ADDENDUM NO. #0

TRACK & FIELD IMPROVEMENTS

Channel Islands High School

April 10, 2020

AD0-C2 C2.0

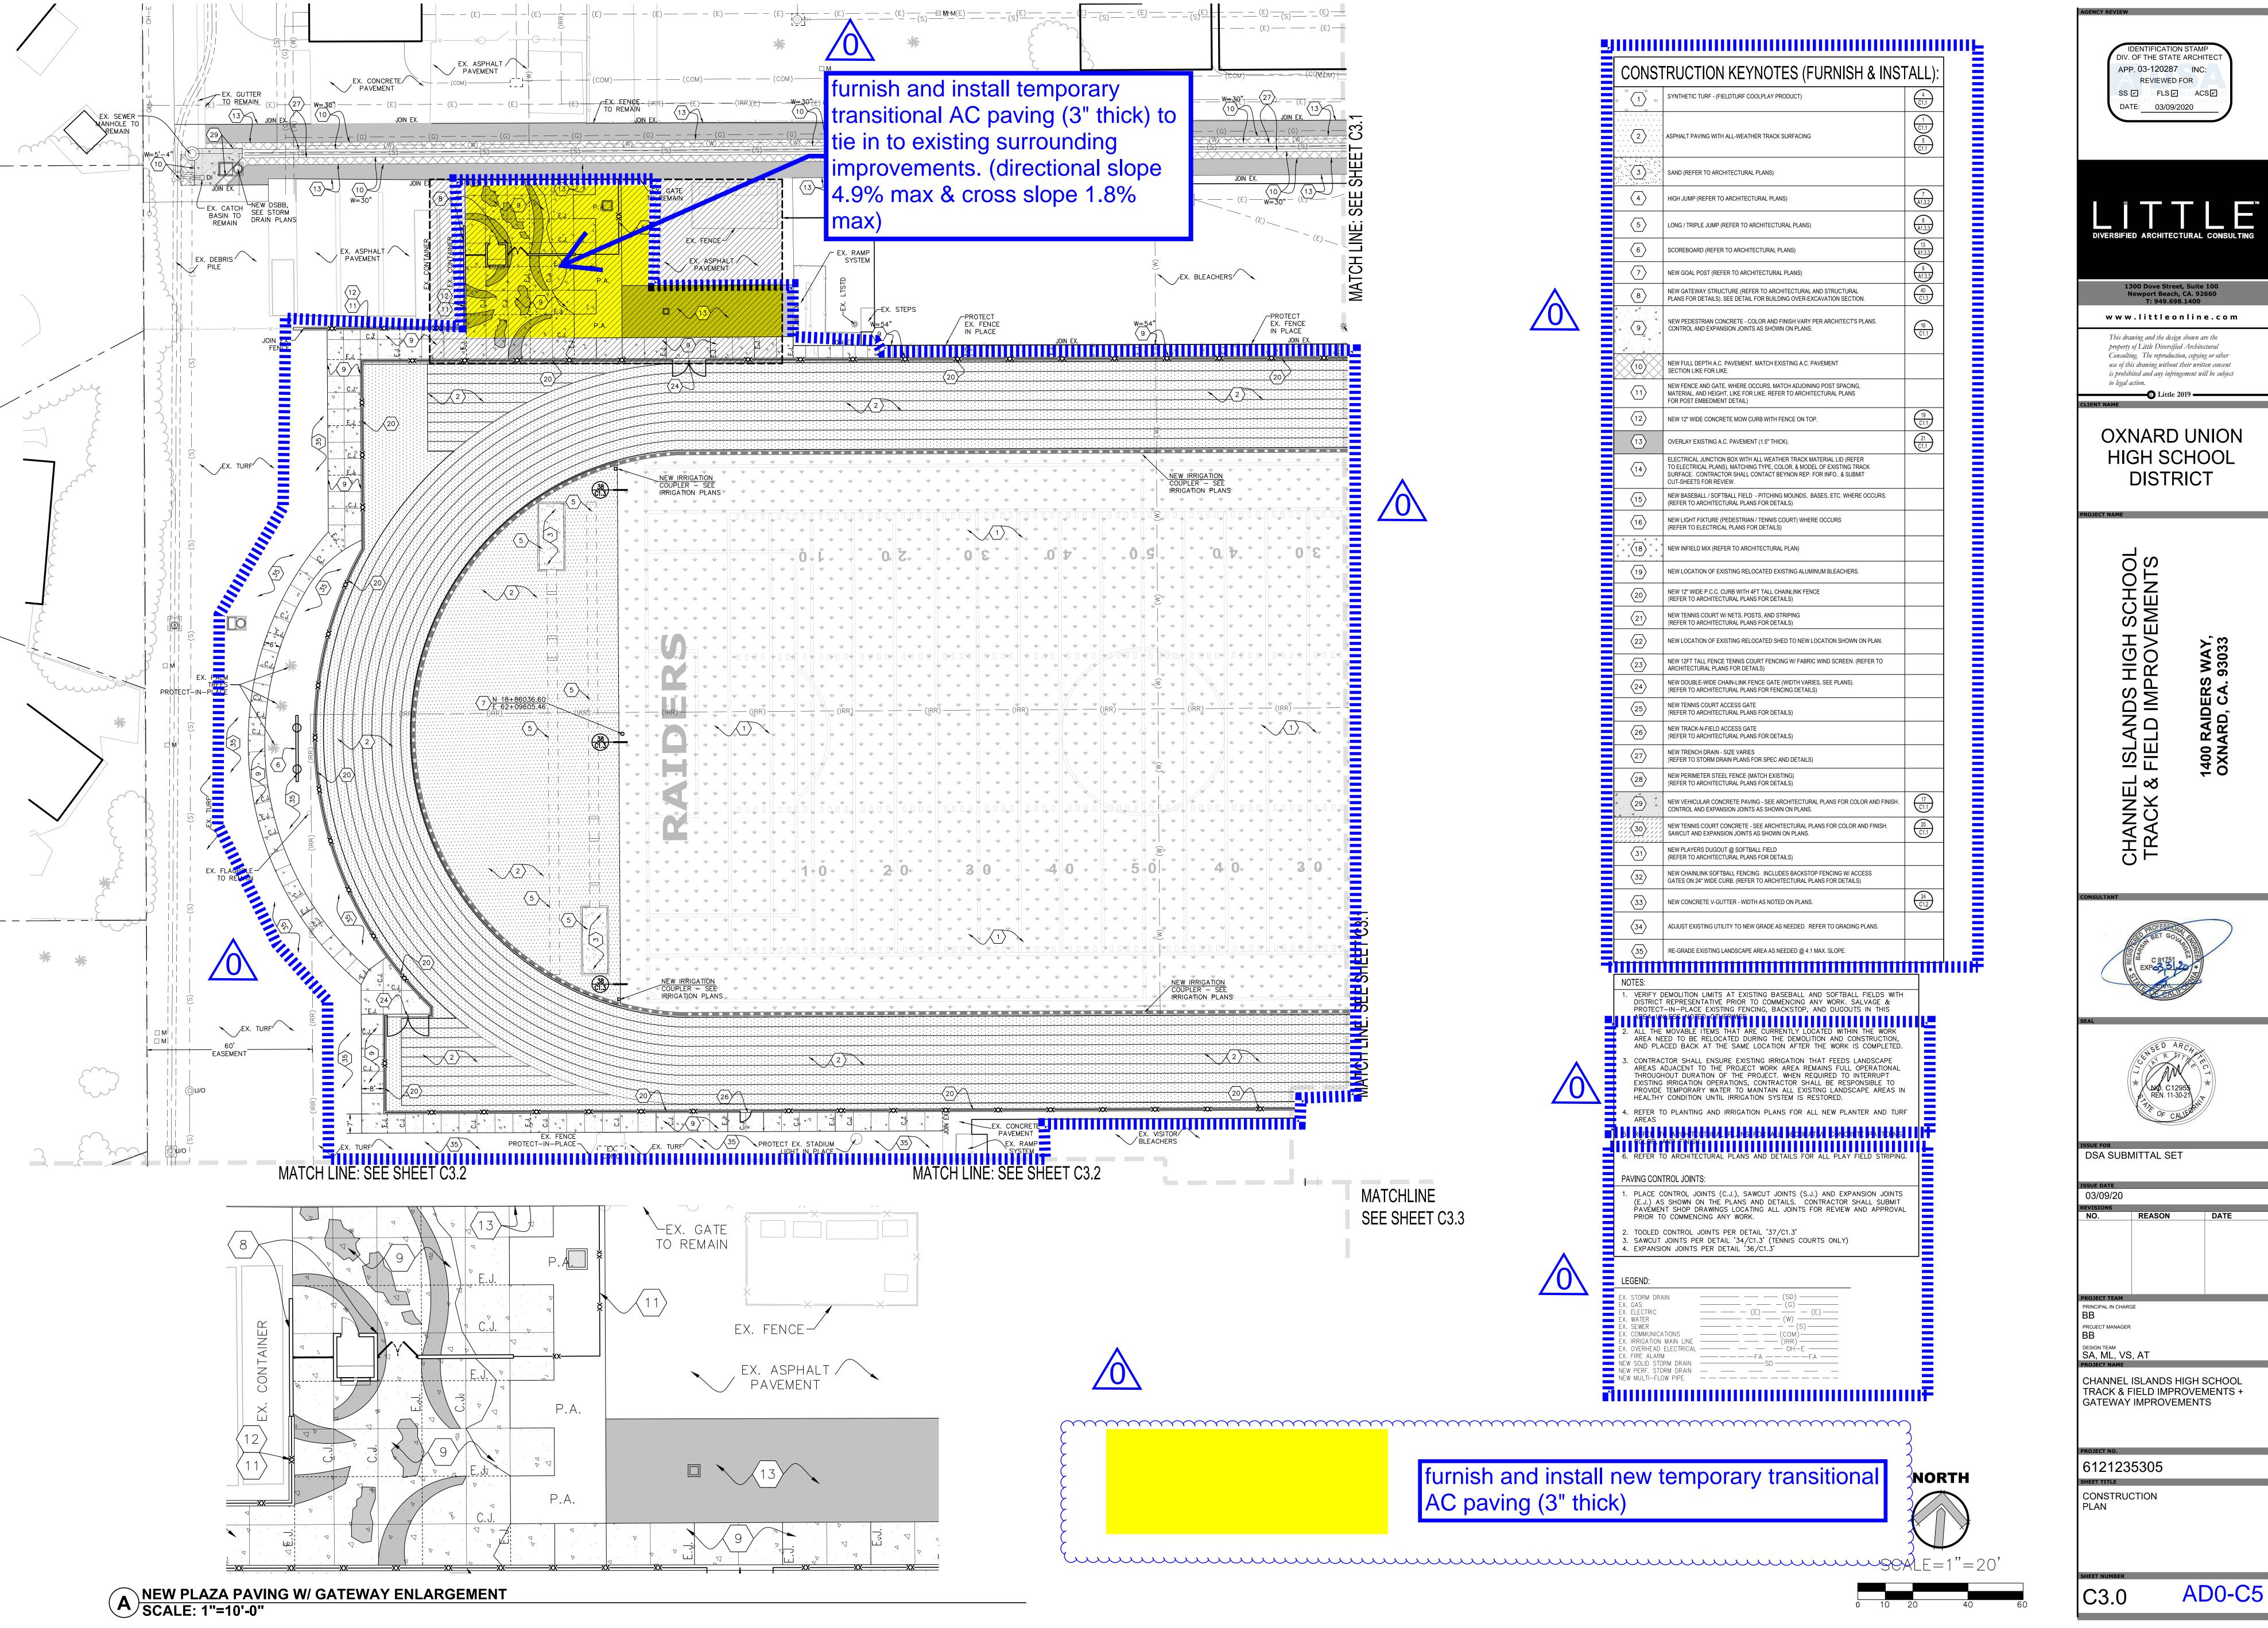
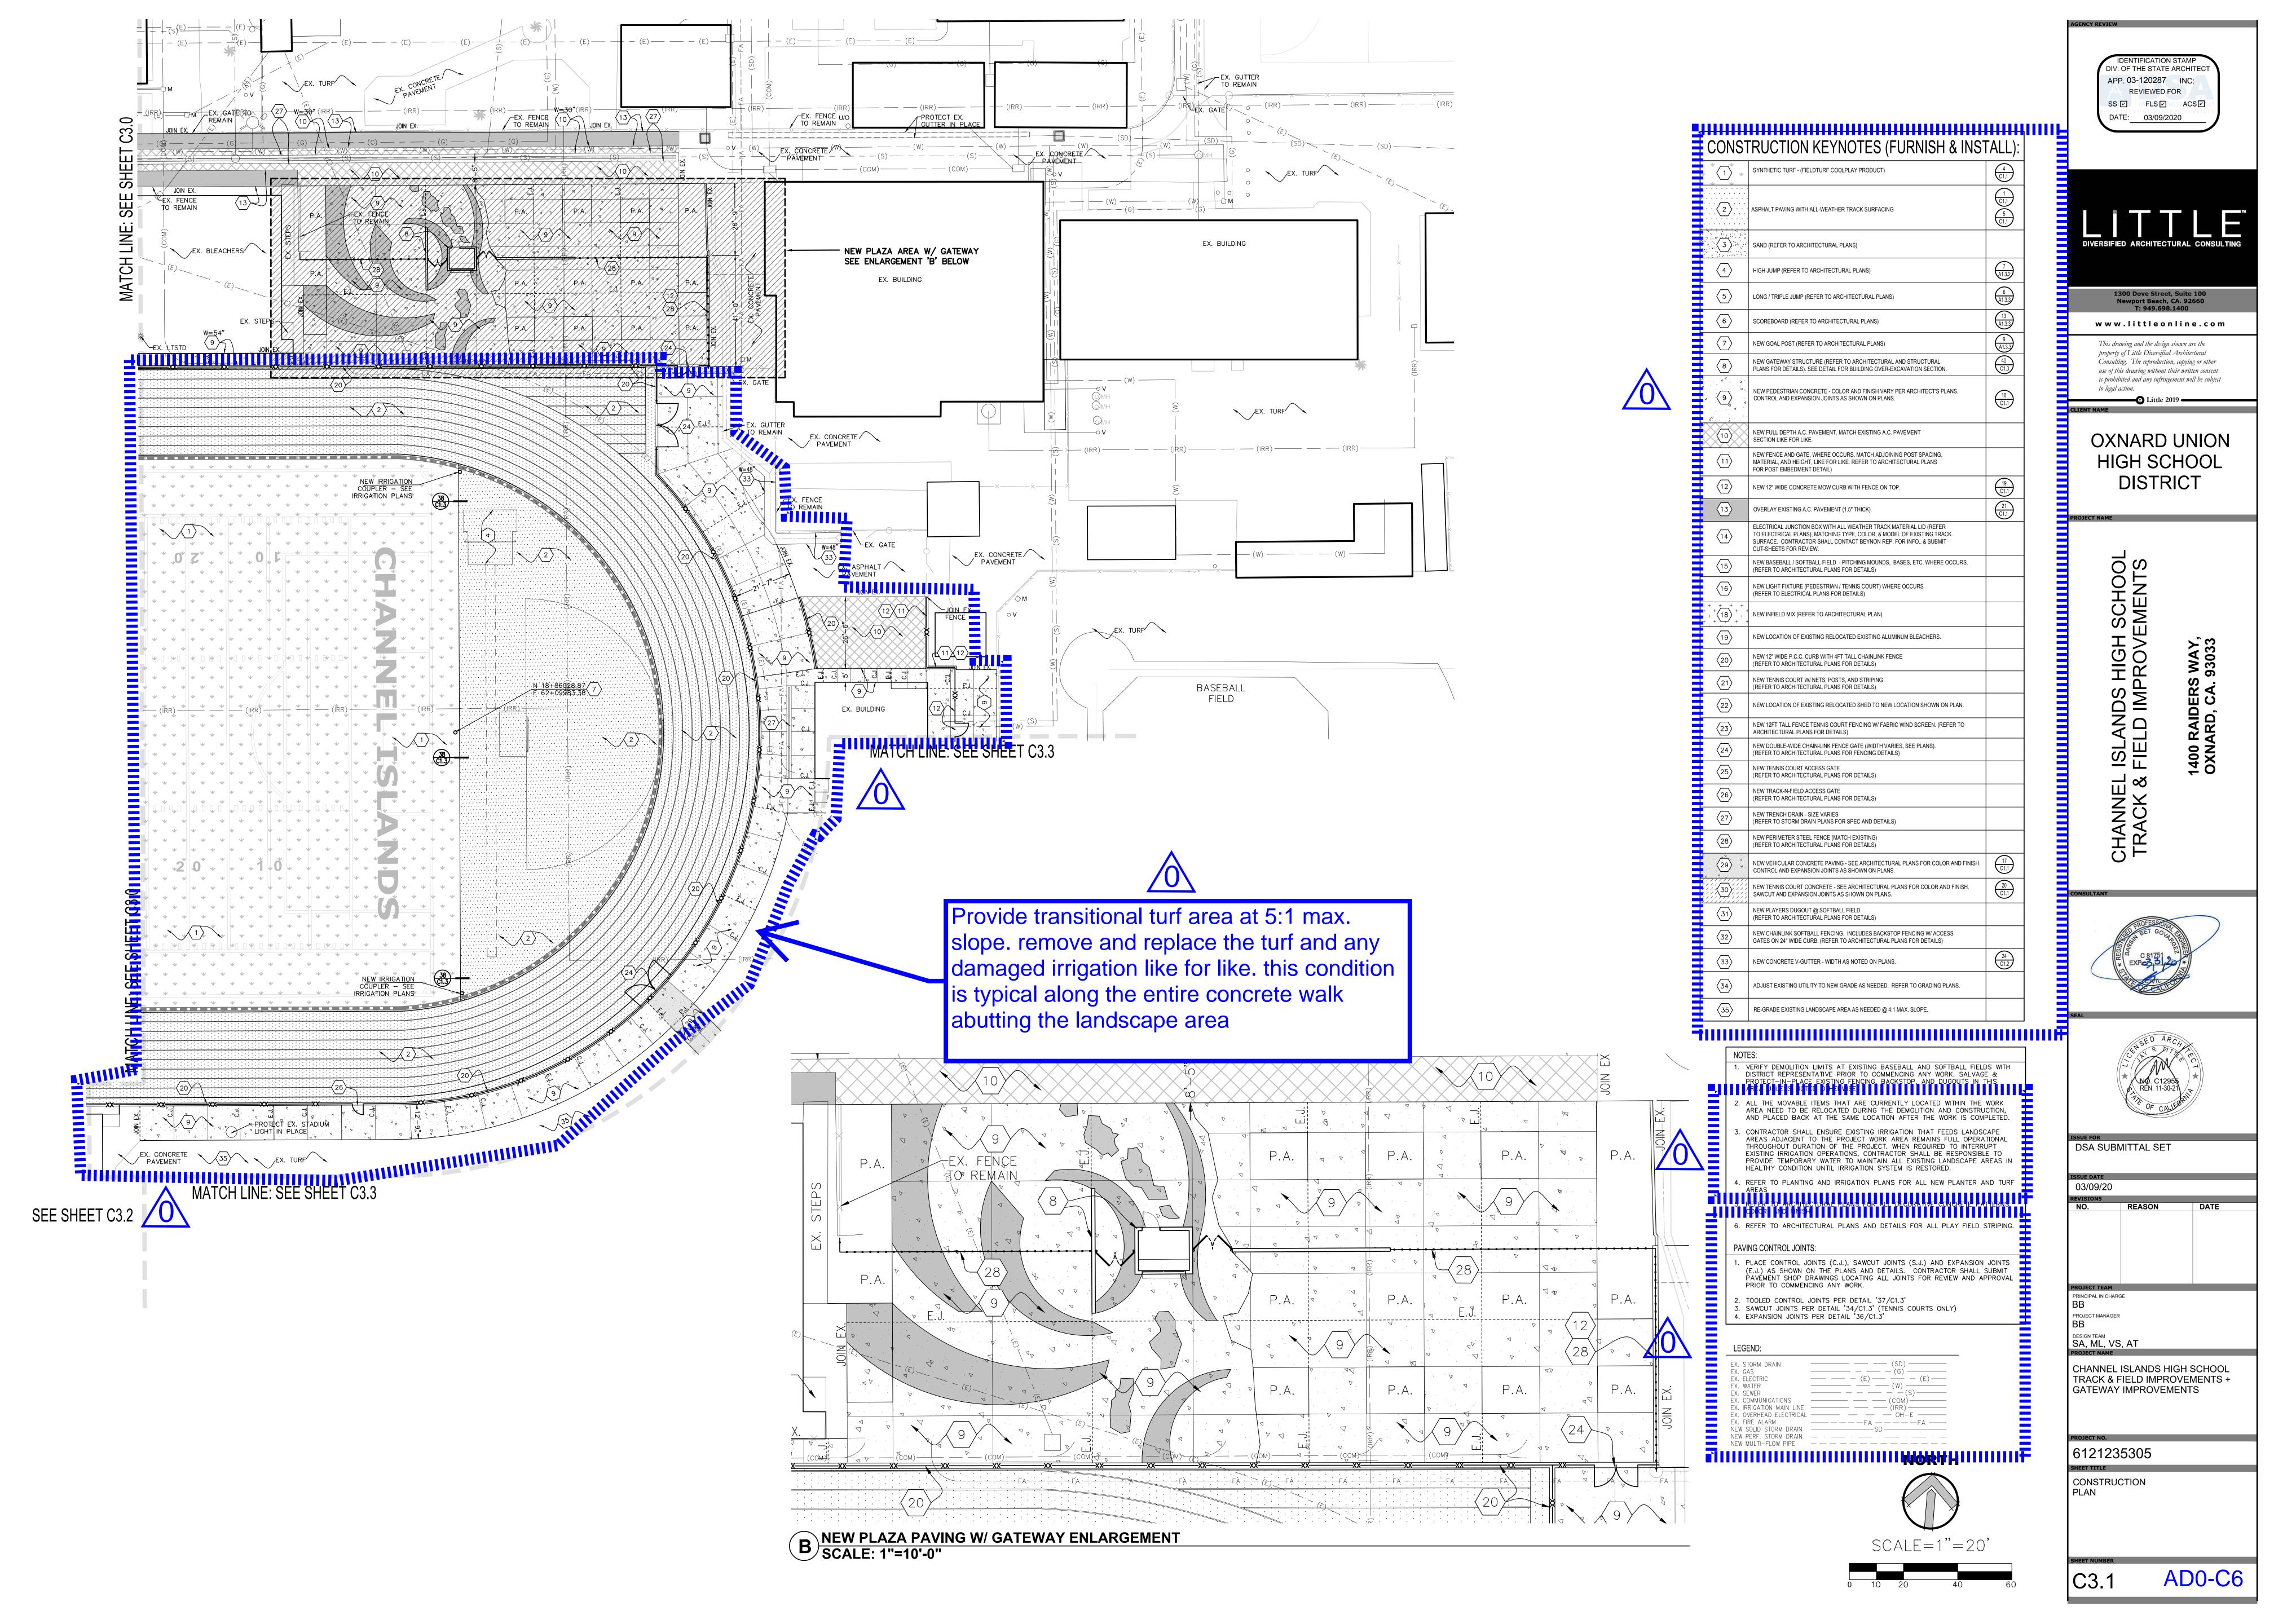
- **3.1.2.2.** Drawing C2.0/AD0-C2 Only work within outlined area is included in scope of this project and bid. Any work shown outside of the delineated area is not part of this project.
